13 Millingandi Road, Millingandi

10 Lot Rural Residential Subdivision

Preferred Project Report

Major Project 06-0032

Looking north along site for proposed Public Road

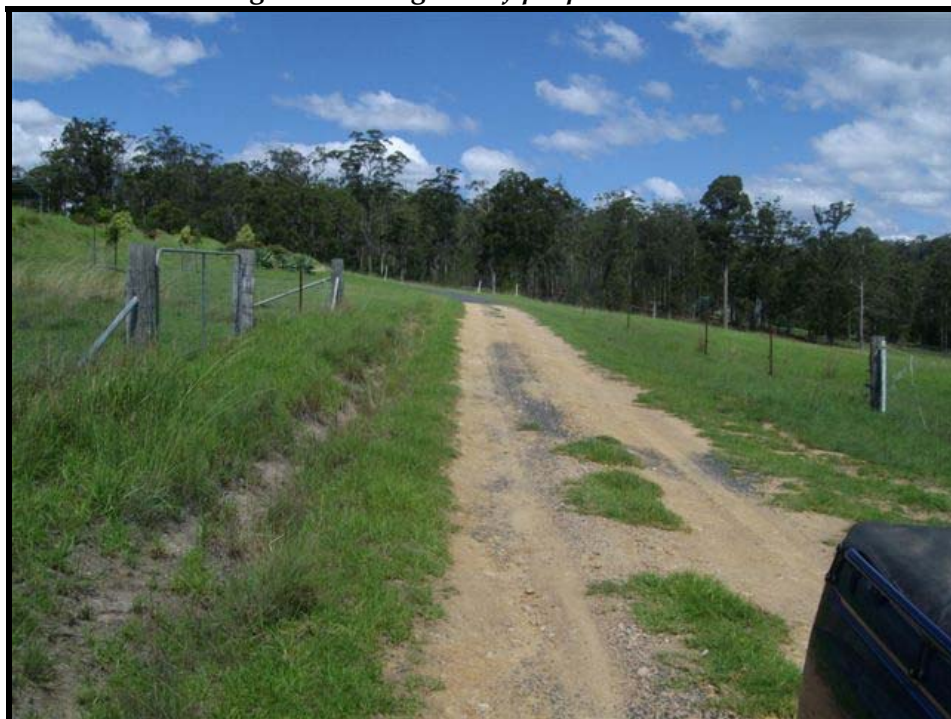
Section 2.6.2 states that the development will not result in the removal of any vegetation. However, the development includes a public road and right of way easement along the eastern portion of the site which may involve the removal of vegetation. Confirm and quantify whether any vegetation removal will be required for the construction of the proposed road.

In addressing the first paragraph of the above, we provide the following photos for your information. As you will note, there will be no vegetation removal in order to provide access to the proposed lots.

The photos provided below show the location of the proposed public road. As you can see the existing access to the property is currently contained within this proposed public road access corridor and will be upgraded to comply with the requirements of DCP 2.
